<b>AMENDMENT OF SOLICITATION/MODIFICATION OF CONTRACT</b>			1. Contract Number	Page of Pages 1   1
2. Amendment/Modification Number DCAM-2008-B-0014-001	3. Effective Date 11/14/2007	4. Requisition/Purchase Request No.	5. Solicitation Caption Eastern Market Rehabilitation

**ADDENDA NO. 1****EASTERN MARKET REHABILITATION**

IFB No. DCAM-2008-B-0014  
 225 7<sup>th</sup> Street SE  
 Washington, DC

**THE DOCUMENTS DATED 19 SEPTEMBER 2007 SHALL BE AMENDED AS FOLLOWS:**

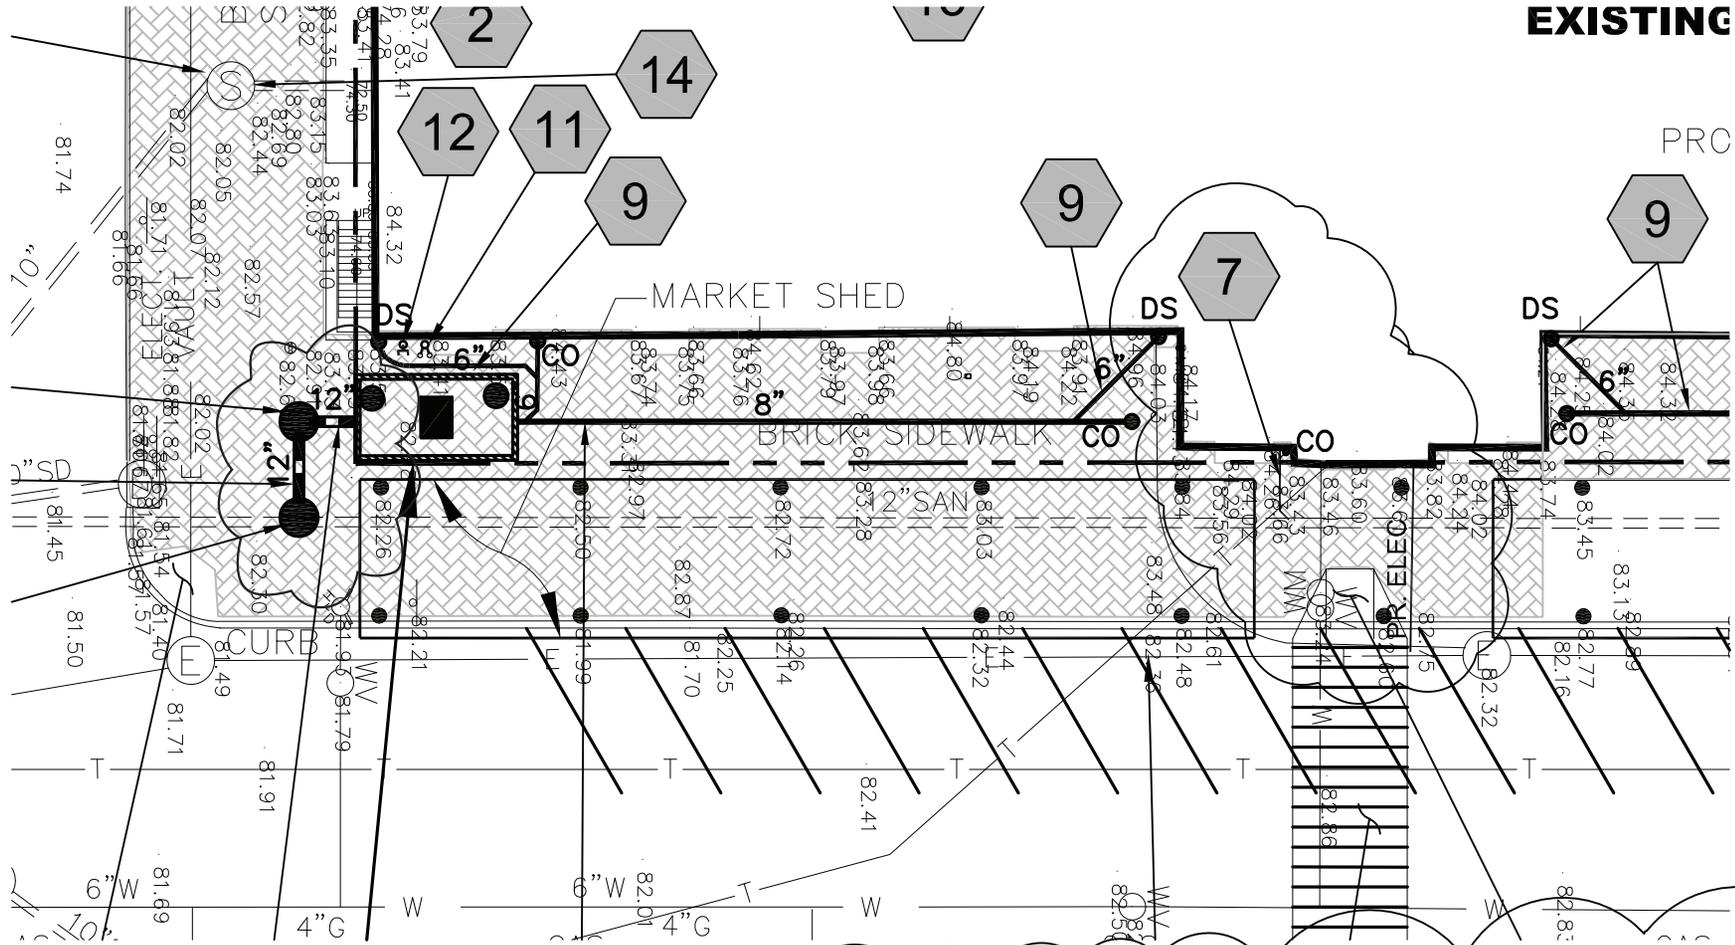
Sheet No.	Change:
G002, G004, A101 to A902	<u>Revise</u> General Note G2 to read “The building will be unoccupied throughout the construction period. On the weekends, vendors utilize the sidewalks to the south, east and north.”
C-1	<u>Revise</u> drawing to clarify demolition of existing sanitary laterals; water house connection, water meter and casing; and waterline tee <b>per attached detail C-1, dated 14 Nov 2007.</b>
C-2	At location D4, <u>revise</u> note to read “See Sheet E100 for duct bank connection”.
C-2	<u>Revise</u> drawing to <u>omit</u> sanitary lateral and manhole over existing combined sewer line at grid location H2 and to <u>add</u> new clean-out and sanitary lateral at grid location H5, <b>per attached detail C-2, dated 14 Nov 2007.</b>

- 1 BULKHEAD EXISTING SANITARY LATERAL AT MANHOLE. PORTION OF LATERAL TO BE ABANDONED, SHALL BE PLUGGED AND FILLED WITH FLOWABLE FILL CONCRETE.
- 2 BULKHEAD EXISTING STORM DRAIN LATERAL AT MANHOLE. PORTION OF LATERAL TO ABANDONED, SHALL BE PLUGGED AND FILLED WITH FLOWABLE FILL CONCRETE.
- 3 REMOVE EXISTING WATER HOUSE CONNECTION, WATER METER AND CASING
- 4 REMOVE EXISTING WATERLINE TEE AND REPLACE WITH STRAIGHT 6" DIP

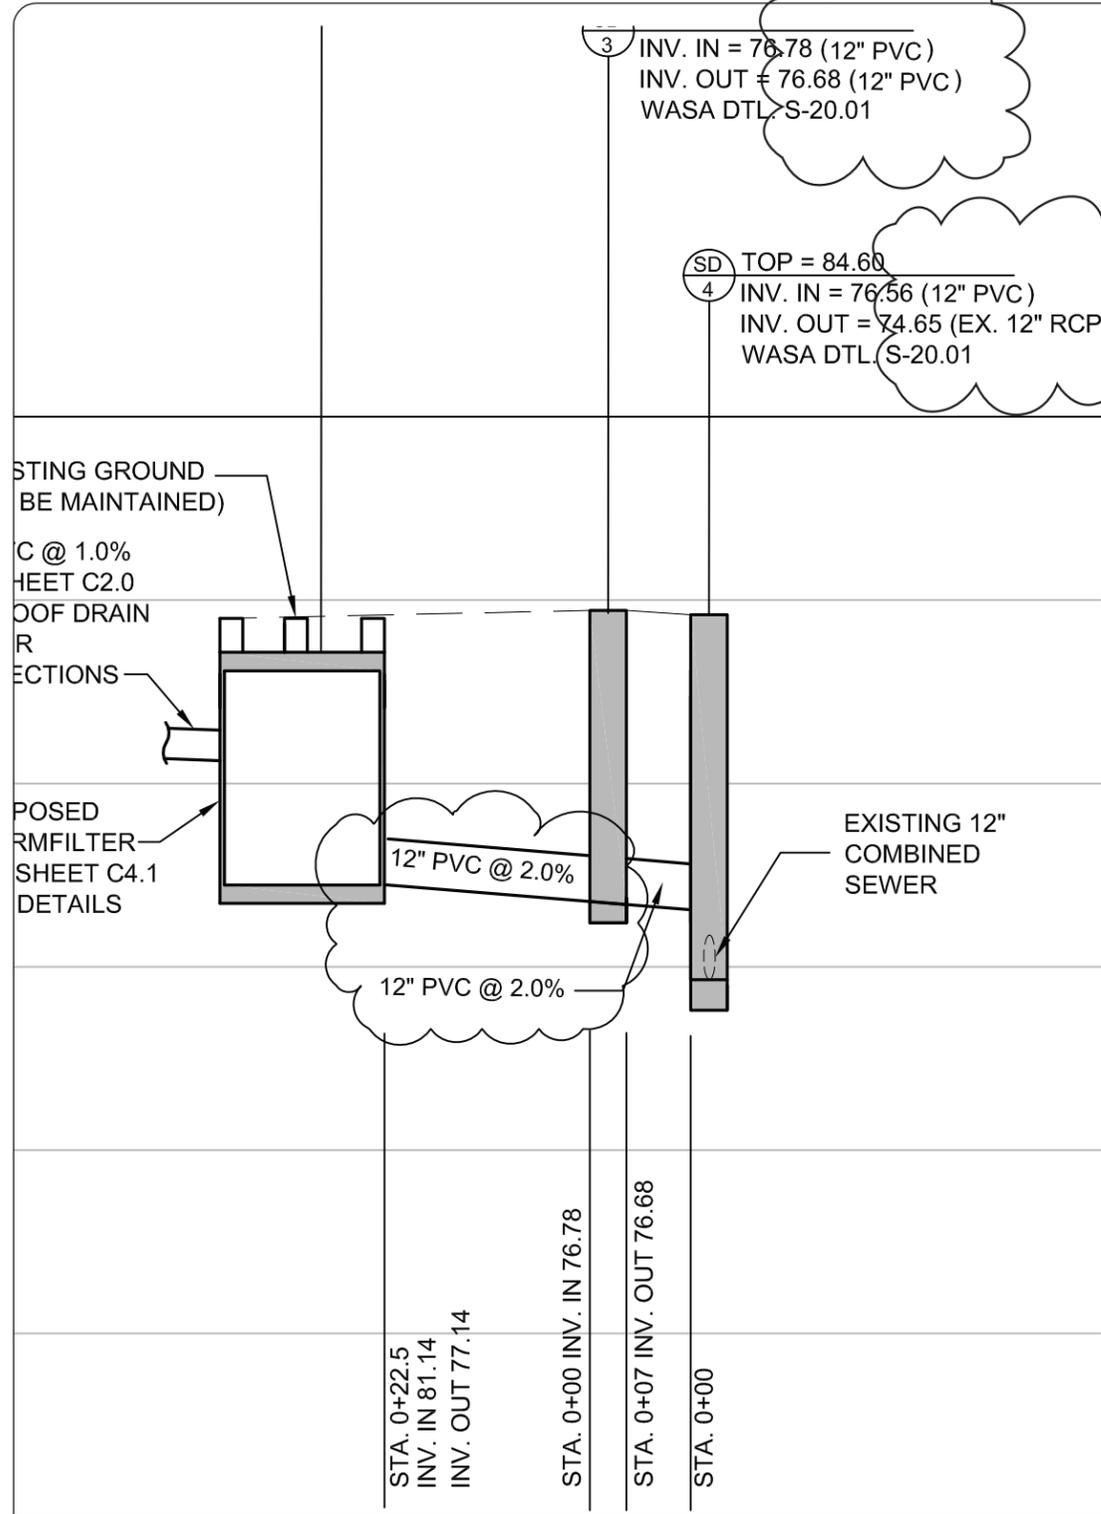
Sheet No.	Change:
C-2.1	<u>Revise</u> "Proposed Storm Drain Profile" to provide 12" PVC @ 5.0% between StormFilter A and SD-1 manhole and SD-2 manhole; <b>see attached detail C-2.1, Sketch No. 1, dated 14 Nov 2007.</b>
C-2.1	<u>Revise</u> "Proposed Storm Drain Profile" to provide 12" PVC @ 5.0% between StormFilter B and SD-3 manhole and SD-4 manhole; <b>see attached detail C-2.1, Sketch No. 2, dated 14 Nov 2007.</b> <u>Revise</u> "Proposed Storm Drain Profile" to provide 12" PVC @ 2.0% between StormFilter C and SD-5 manhole and SD-6 manhole; <b>see attached detail C-2.1, Sketch No. 2, dated 14 Nov 2007.</b>
C-2.1	<u>Revise</u> "New Sanitary Sewer" to <u>omit</u> manhole over existing combined sewer and <u>revise</u> 2" PVC force main to 6" PVC @ 10.0% between building and existing combined sewer; <b>see attached detail C-2.1, Sketch No. 3, dated 14 Nov 2007.</b>
C-2.1	<u>Revise</u> "New 6" Fire Service" to omit tapping sleeve and provide tee; <b>see attached detail C-2.1, Sketch No. 4, dated 14 Nov 2007.</b> <u>Revise</u> "New 4" Domestic Service" to provide a 4" water meter and vault, and a tee, valve and reducer; <b>see attached detail C-2.1, Sketch No. 4, dated 14 Nov 2007.</b>

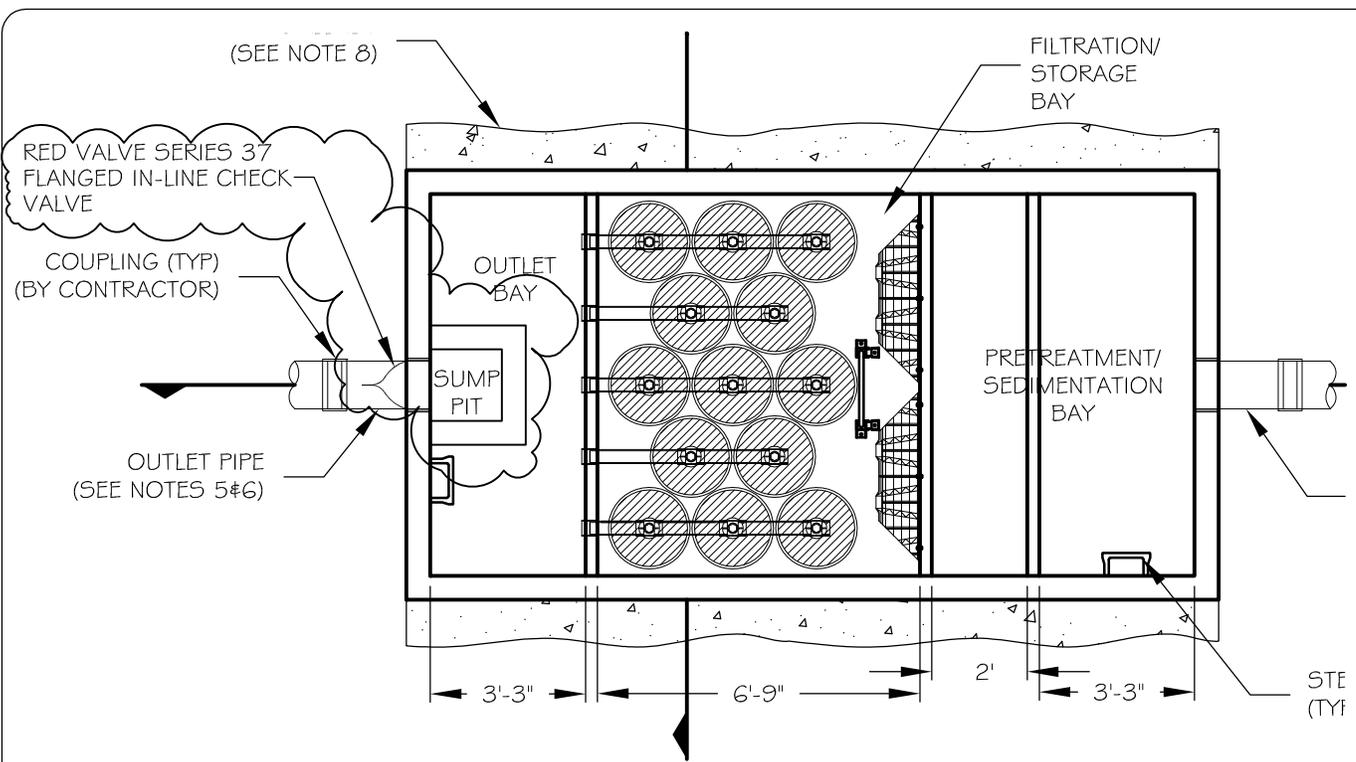
C-2.1	<u>Omit</u> Structure Number CS-1 from the "Utility Structure Schedule"; <b>see attached detail C-2.1, Sketch No. 5, dated 14 Nov 2007.</b>
C-4.1	<u>Add</u> red flange series 37 flanged in-line check valve and gas trap with sump pit to 8'x16' volume StormFilter <b>per attached detail C-4.1, Sketch 1, dated 14 Nov 2007.</b>
C-4.1	<u>Revise</u> StormFilter outlet pipe size and material <b>per attached detail C-4.1, Sketch 2, dated 14 Nov 2007.</b>
A101	<u>Revise</u> drawing A1, Note 1 to read "Existing concrete slab in basement to replaced complete, U.O.N.; see structural drawings."
A101	<u>Revise</u> drawing K1, Note 1 to read "Existing concrete slab in basement to replaced complete, U.O.N.; see structural drawings."
A151a	<u>Add</u> painting detail for the South Hall trusses <b>per attached detail ASK1.1, dated 14 Nov 2007.</b>
A601	<u>Revise</u> Finish Schedule, Room 108, North Hall, Ceiling "Finish" column to read "P07@wood purlins & roof deck; P08@steel trusses"

PROJECT NO. EA710B
BLDG ID NO. 47
DATE: 14 NOV 2007
DRAWING NUMBER P9/A801

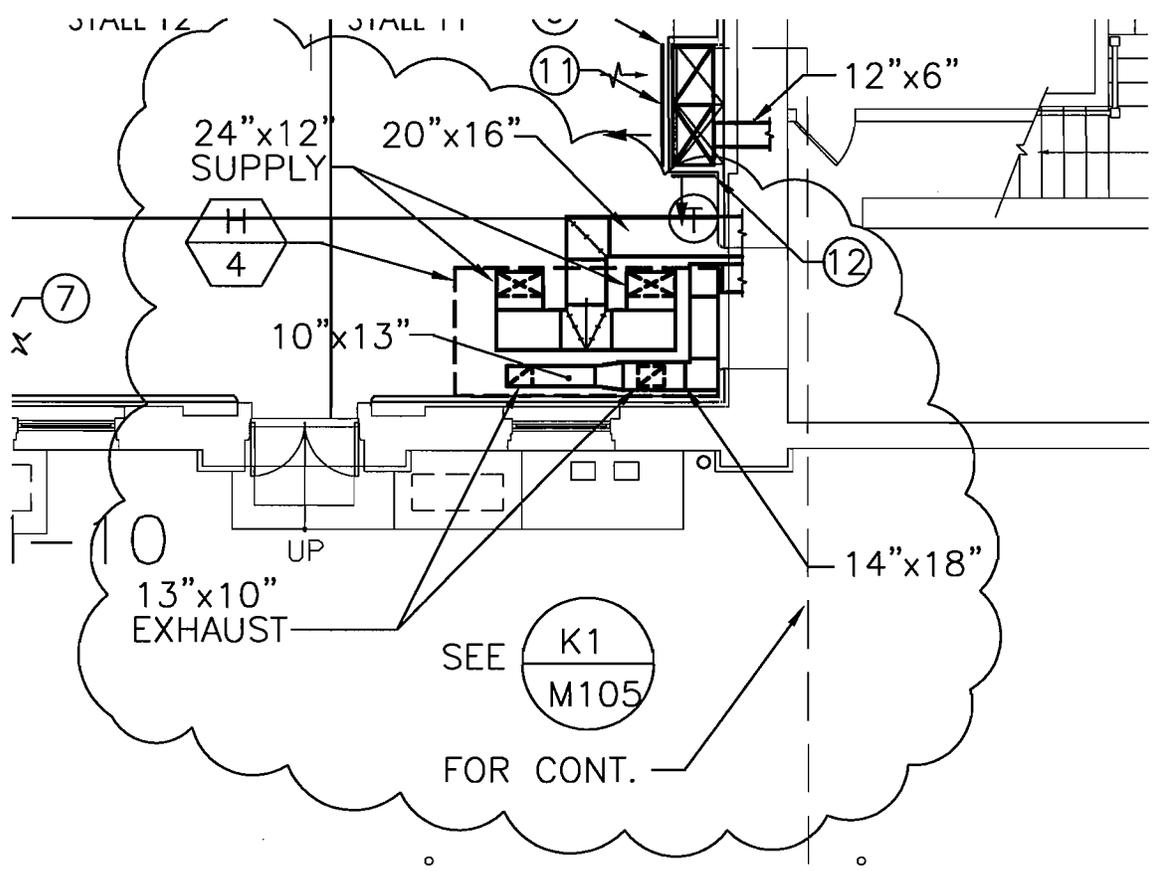
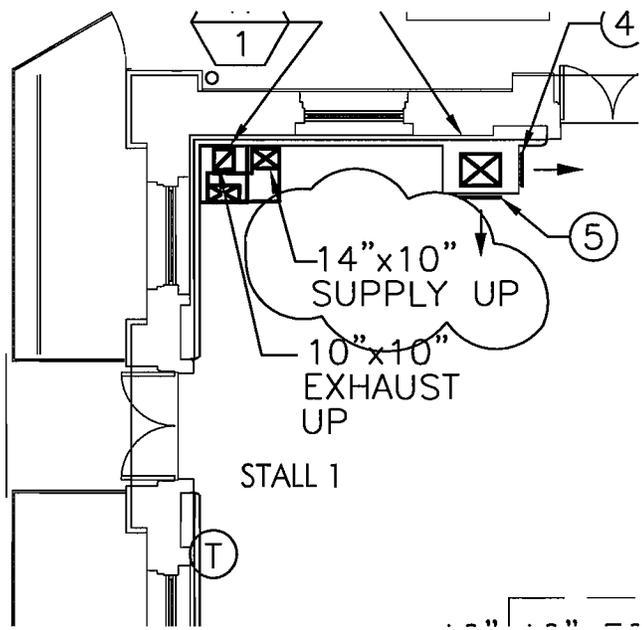
A801	<u>Revise</u> detail P9 "Bsmt Pier Repointing Detail" to clarify the work required <b>per attached detail, P9/A801, dated 14 Nov 2007.</b>
M103	<u>Revise</u> drawing A1 as described below and <b>per attached detail, A1/M103, dated 14 Nov 2007.</b> <ol style="list-style-type: none"> <li>1. At grid location G2, <u>revise</u> to the supply duct size indicated.</li> <li>2. At grid location C14, <u>revise</u> the ductwork associated with exhaust hood H-4 at the First Floor, South Hall, as indicated.</li> </ol>
M104	<u>Revise</u> drawing titleblocks to read "A1/M104" and "K1/M104".
M104	<u>Revise</u> drawing A1 to modify the rooftop layout of exhaust fans F-17 and F-18 and the make up air units MUA-1 and MUA-2 and to provide intake duct extensions, <b>as indicated on the attached detail, A1/M104, dated 14 Nov 2007.</b> <u>Add</u> key note 2 to read "Sit equipment on curb per manufacturer's recommendations; <b>see attached detail, A1/M104, dated 14 Nov 2007.</b>

KEYNOTES SHEET A801:  
04-25 REPOINT EXISTING BRICK.

GROTHEER & COMPANY 1612 K STREET NW, SUITE LL-3 WASHINGTON, DC 20006 (202) 223-5752	EASTERN MARKET REHABILITATION DC OFFICE OF PROPERTY MANAGEMENT WASHINGTON, DC	PROJECT NO. EA710B BLDG ID NO. 47 DATE: 14 NOV 2007 DRAWING NUMBER B1,K1/M105
	ADDENDUM NO. 1 DRAWING TITLES	
SCALE: 1/8" = 1'-0"

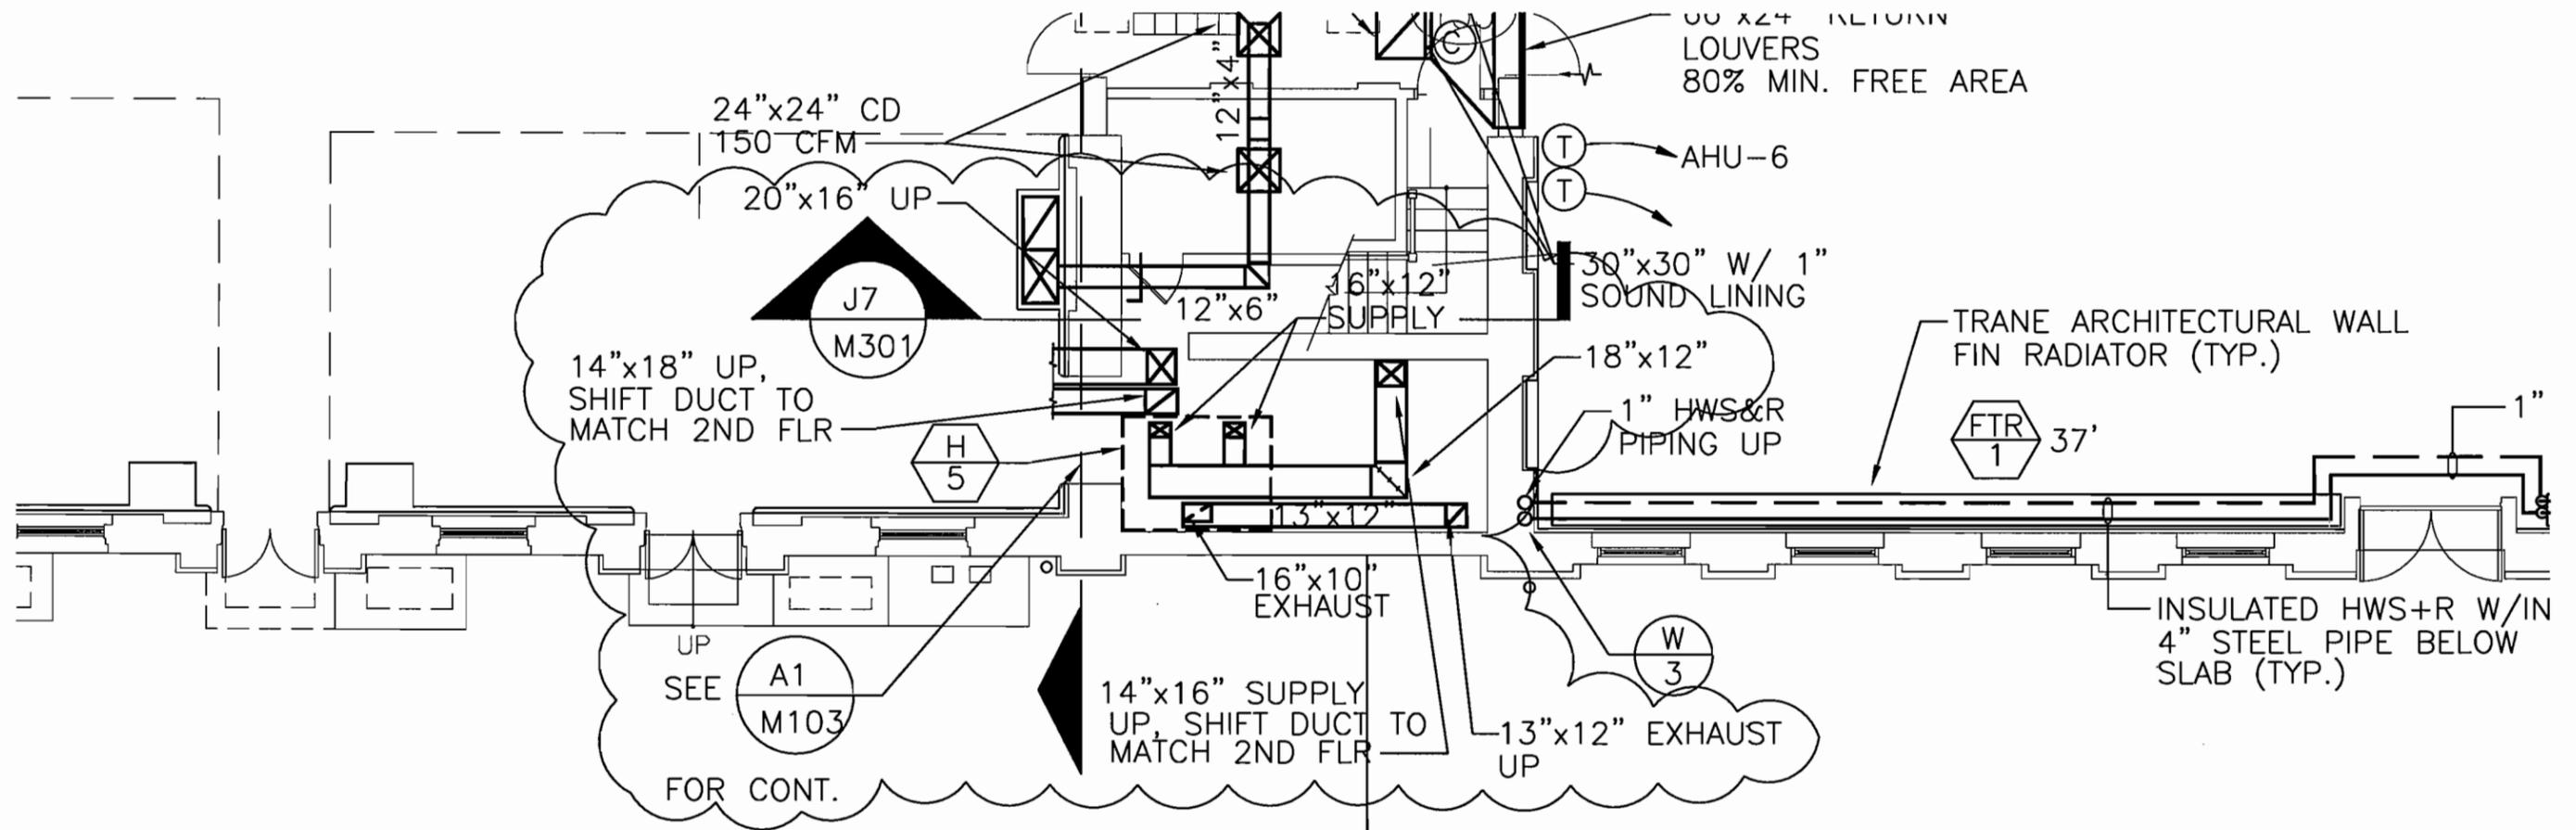
M105	<u>Revise</u> drawing titleblocks to read "B1/M105" and "K1/M105". <u>Revise</u> ductwork for exhaust hoods H-4 and H-5 at the First Floor, Center Hall, <b>as indicated on the attached detail, A1/M104, dated 14 Nov 2007.</b>
